U.S. Department
of Transportation
**Federal Highway
Administration**

In Reply Refer To:
HSST/B-218

Name of system: F-Shape Reinforced Concrete Barrier with Slotted Drain Holes
Type of system: Permanent F-Shape Reinforced Concrete Barrier
Test Level: National Cooperative Highway Research Program (NCHRP) Report 350
Test Level 4 (TL-4)
Testing conducted by: Texas Transportation Institute (TTI)
Date of Request: December 9, 2010
Drawing Designator: SBC04d

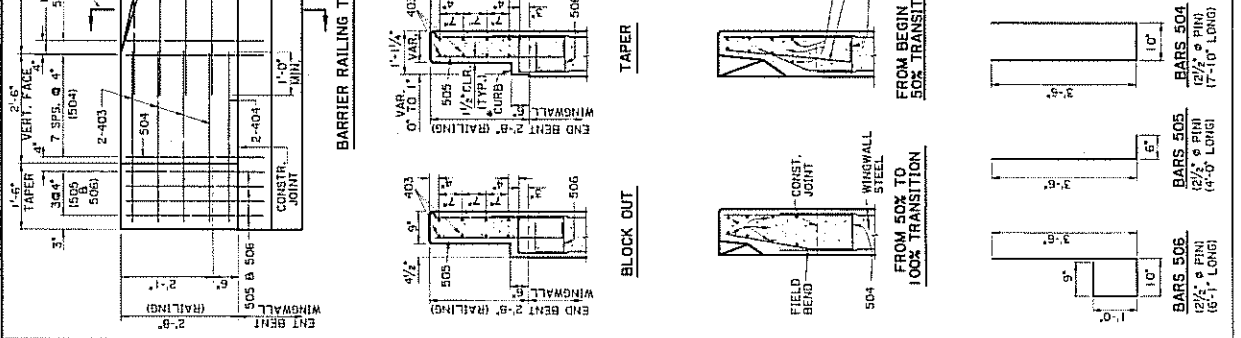
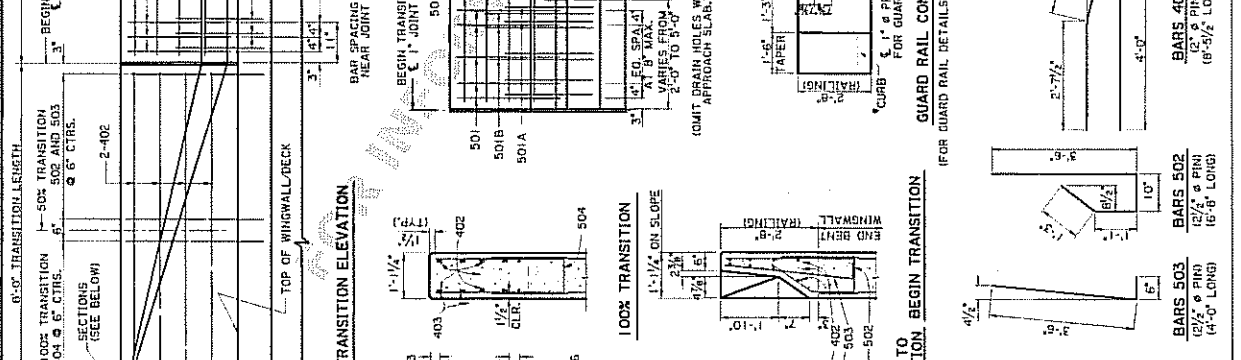
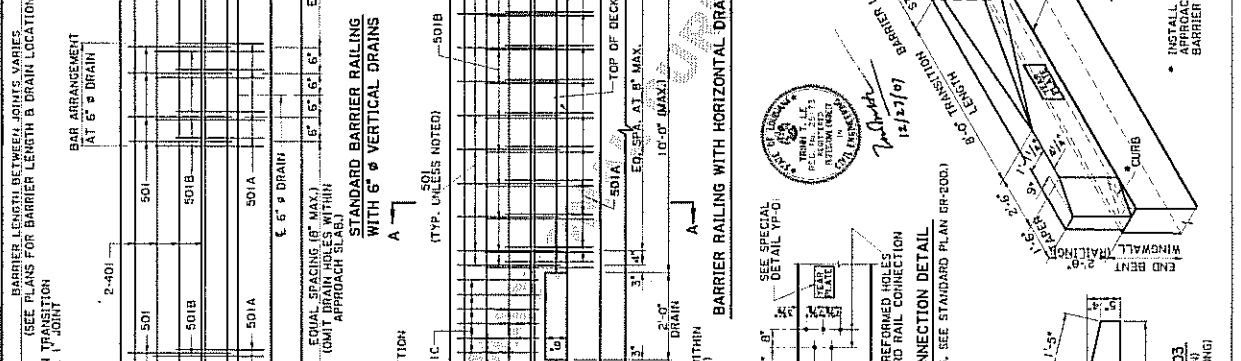
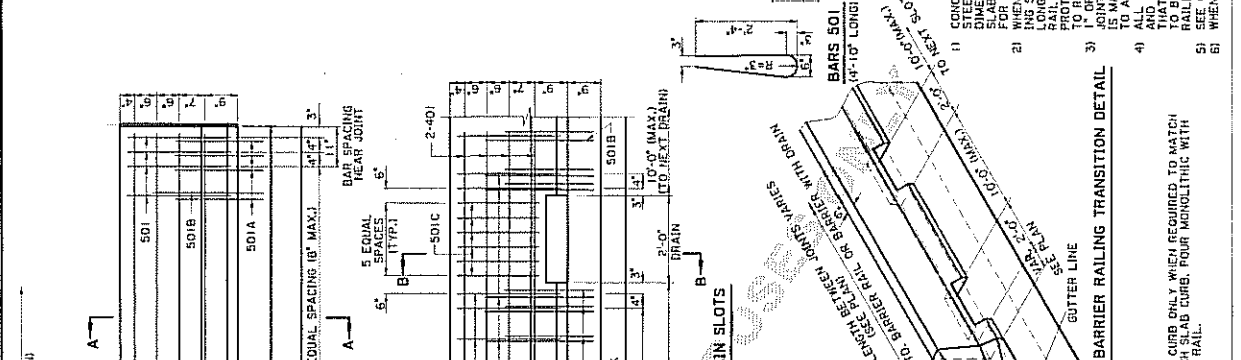
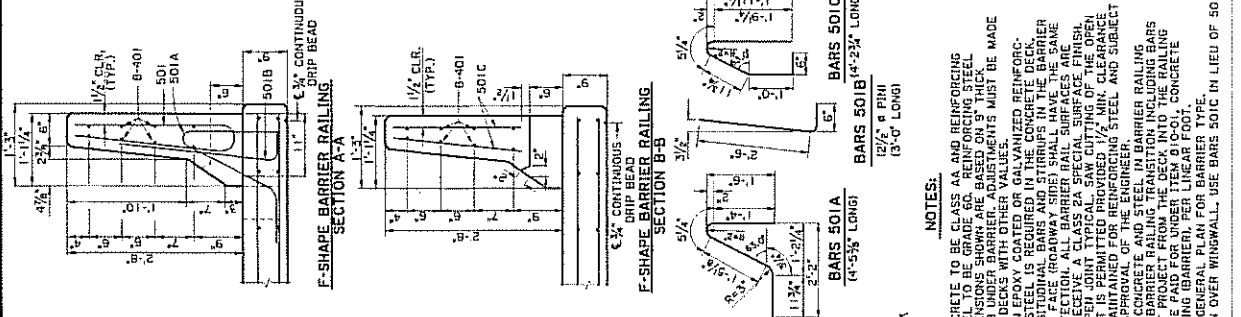
through the bridge rail. La DOTD has proposed the use of 6 inches high x 24 inches long open slots located 10 feet apart at the base of the rail to accommodate drainage through the railing. Details of the proposed bridge rail are provided as enclosure to this correspondence.

Details including a side-by-side comparison between size openings of TXDOT Wildlife Crossing Barrier, WSDOT barrier, and LaDOTD F-Shape Barrier with drainage slots are provided as enclosure to this correspondence.

Therefore, the system as described in the request above and detailed in the enclosed drawings is acceptable for use on the NHS under the range of conditions tested, when such use is acceptable to a highway agency.

Figure 76 – LaDOTD F-Shape Barrier, TXDOT Wildlife Crossing Barrier WSDOT Pin & Loop Barrier Cross-Sections

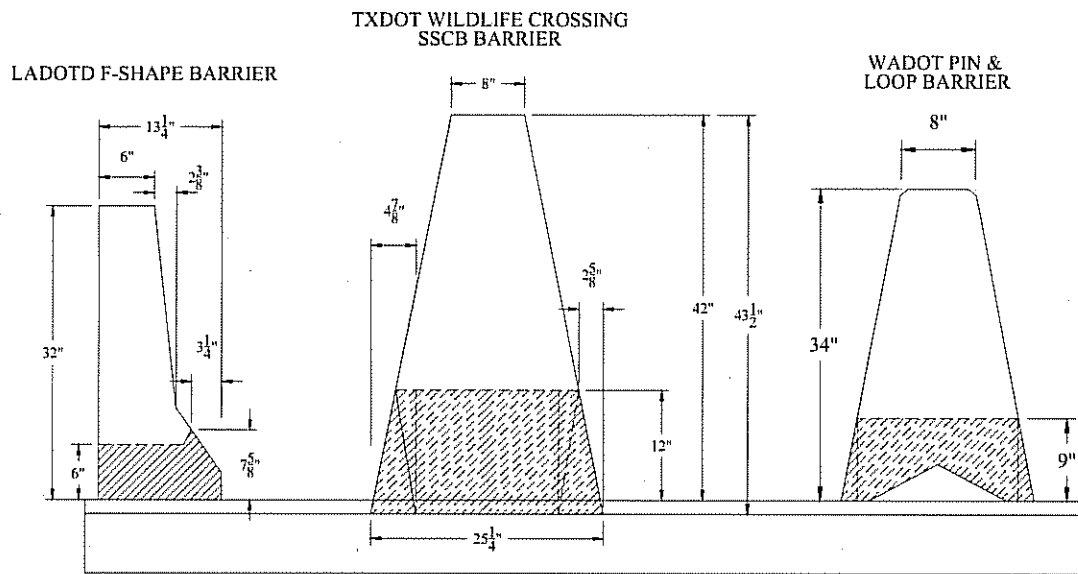
The proposed drainage slot details were compared with other barriers systems utilizing similar type slots. This review consisted of comparisons with the Texas Department of Transportation (TXDOT) Single Slope Concrete Barrier (Wildlife Crossing) Precast SSCB (TXDOT Wildlife Crossing Barrier) and the Washington Pin & Loop Barrier System designed and successfully crash tested by TTI for the Washington State Department of Transportation (acceptance letter HSSD/B-206). The TTI researchers performed a similar review of the TXDOT Wildlife Crossing Barrier for TXDOT with respect to the size and potential interaction of these openings with respect to the small car and pickup truck for the NCHRP Report 350 crashworthiness criteria.

The ratio in height of the contact length of the F-Shape Barrier to 32 inches total height of rail (i.e., rail contact width to height) is 0.762. Based on the proposed barrier geometry and the information provided in AASHTO Figure A13.1.1-3, the proposed barrier is considered marginal.

The analysis of the drainage slot used in the Washington State Department of Transportation Pin & Loop Barrier (WSDOT barrier) appeared to perform well in LS-DYNA impact simulations with both the small car and pickup truck. Although the WSDOT barrier did not meet the AASHTO Manual for Assessing Safety Hardware test specifications, the 9-inch high drainage slot specified used in the WSDOT barrier system did not adversely affect the performance of the crash vehicle. In addition, the potential for vehicle interaction with the drainage slot opening was considered low to marginal with respect to the criteria as provided in

AASHTO Section 13 specifications. Based upon the researchers' analysis, the F-Shape barrier with drainage slots is considered acceptable with respect to Report 350 TL-4 performance criteria.
